މާލުދިވެހިރާއްޖޭގެ ސަރުކާރުގެ ގެޒެޓް	ގަވާއިދުގެ ނަންބަރު:
(IUL)266-PR/266/2025/25	މާލުދިވެހިރާއްޖޭގެ ސަރުކާރުގެ ގެޒެޓް
11 ޖުލައި 2025	މާލުދިވެހިރާއްޖޭގެ ސަރުކާރުގެ ގެޒެޓް

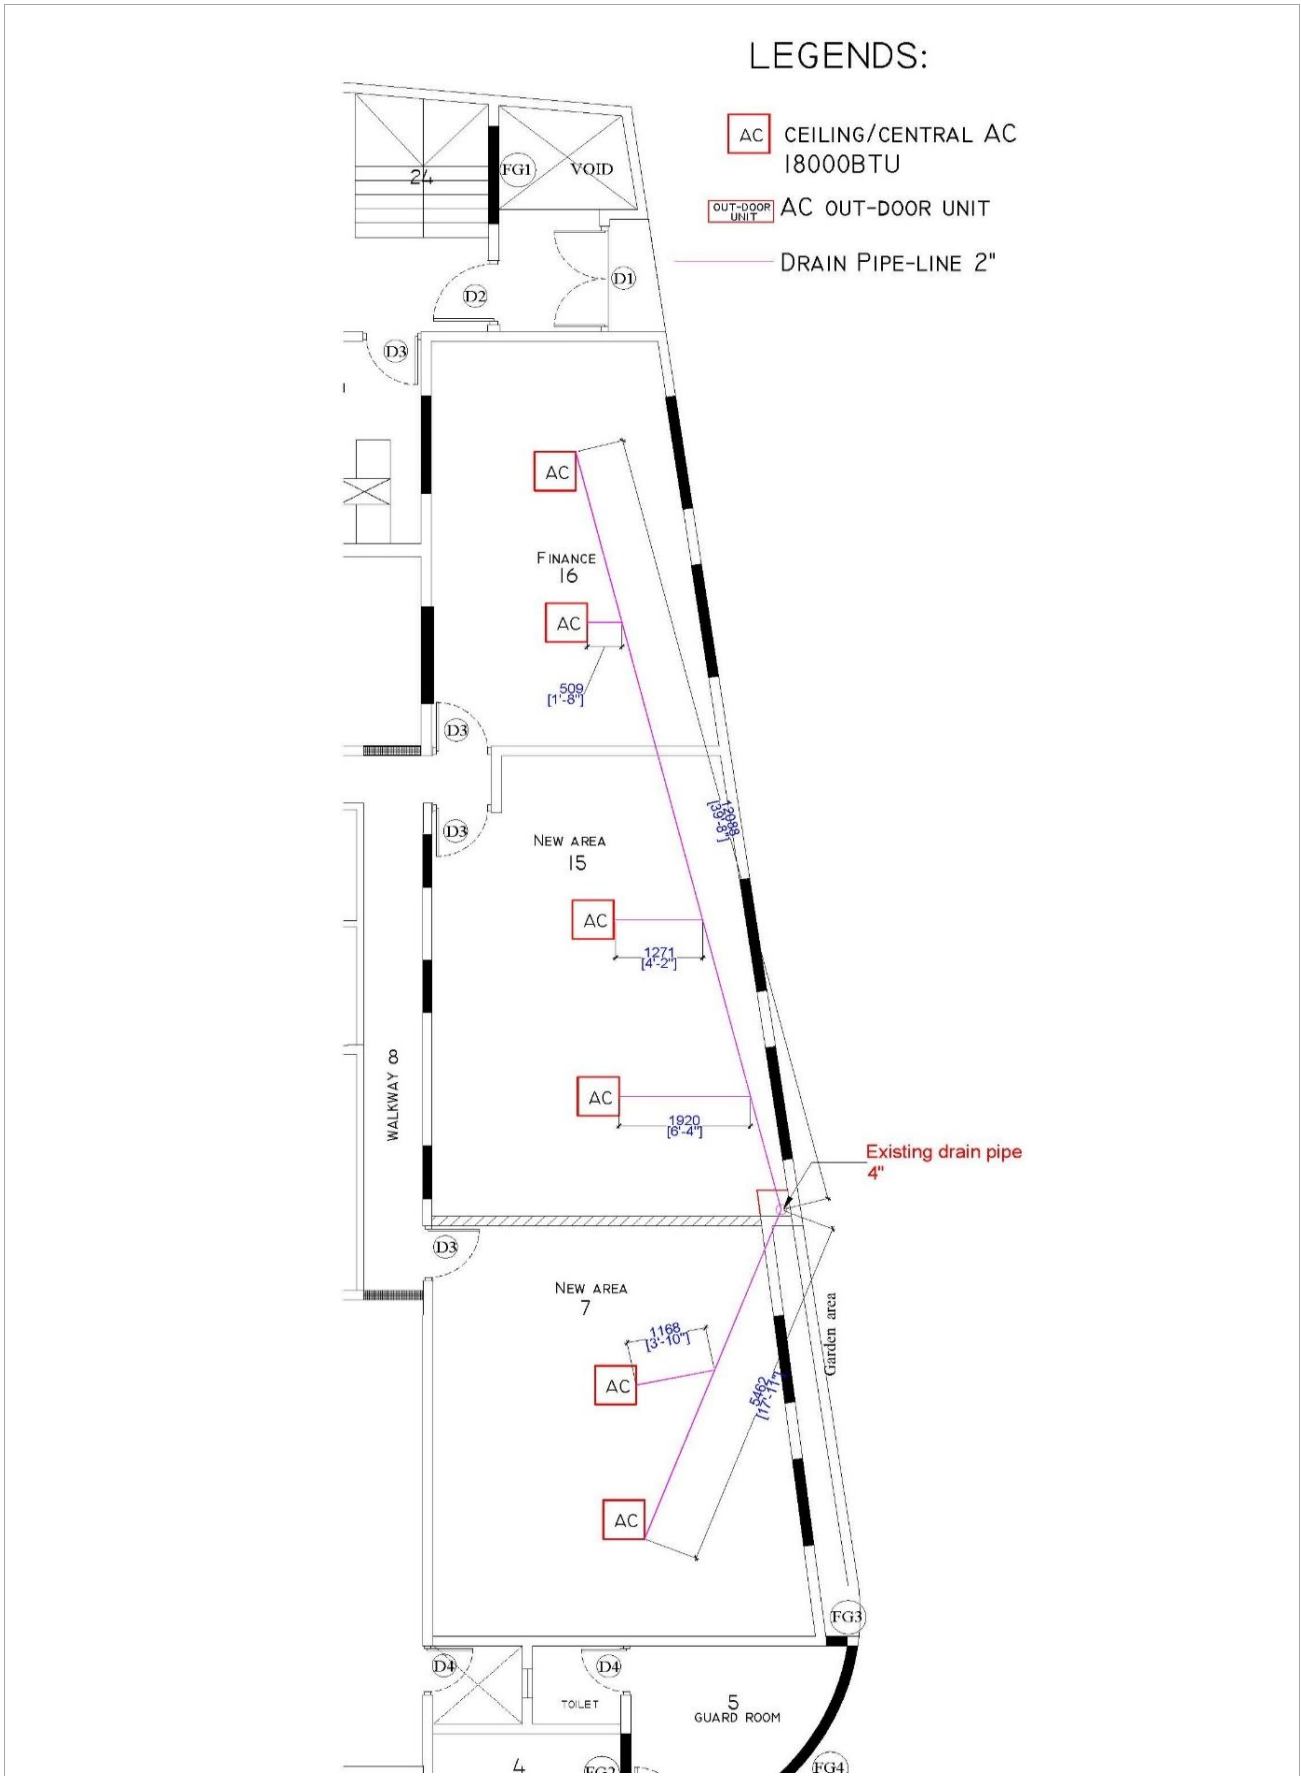
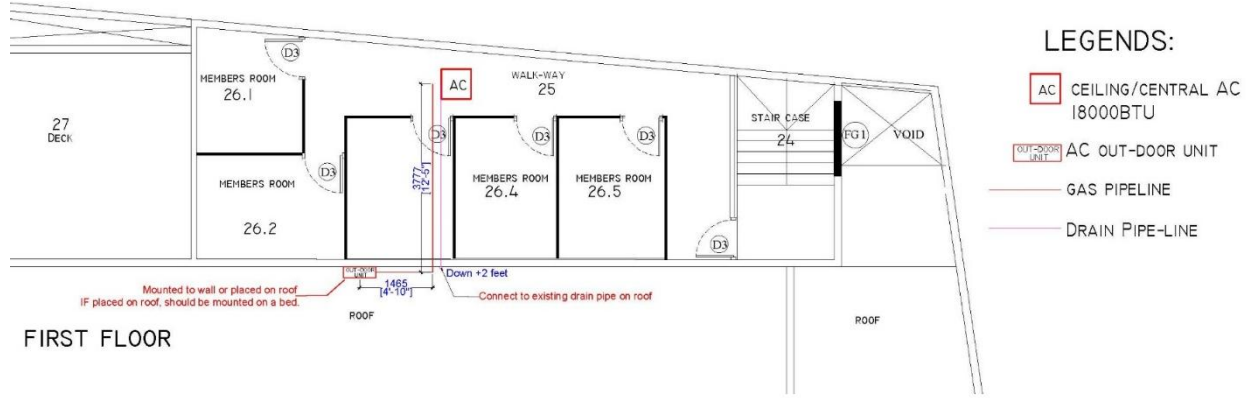
1. Approx distance from indoor unit to outdoor unit for each.

3. How many drain pipes, as per the drawing 6 AC were in a row, one AC was separate, Do u need 02 separate pipes, or the separate unit to connect the main 6 AC main pipe.

- All pipe lines (Gas lines and Drain pipe-lines) are shown in the drawings for clear understandings. (However, the dimensions might not be very accurate.

- Total 3 pipes, the 6 AC in which is a row should be connected to the existing (4") drain pipe through 2 separate drain pipes (2") that runs on ceiling.
- The 7th AC, (Separate AC) drain pipe should be connected to the existing drain pipe in roof. (Not the garden area).
- All pipe lines (Gas lines and Drain pipe-lines) are shown in the above drawings (drawings attached to question 1) for clear understandings. (However, the dimensions might not be very accurate.)

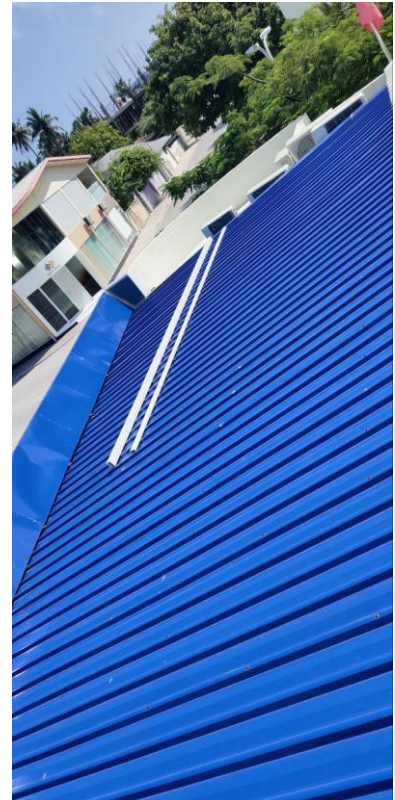
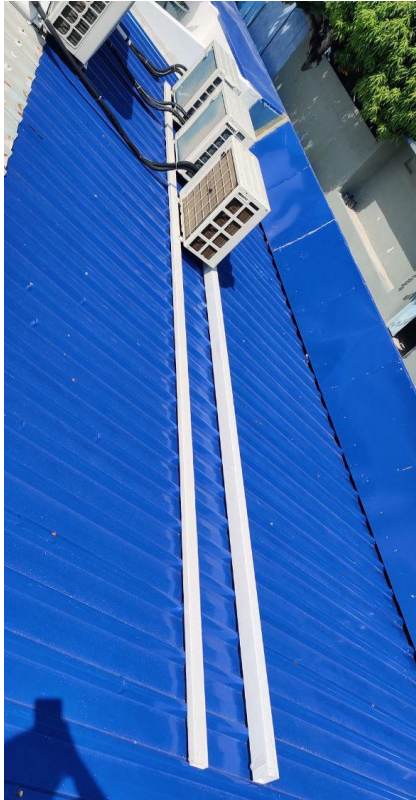
4. Outdoor unit installation bed drawing or a picture of existing bed.

- The bed is made using 2 rectangular Hollow sections. Adjusting to the outdoor unit's size and placement.
- The bed should be mounted to roof, in-line/ using the same screws on the roof.
- Photos of the existing bed is attached below.
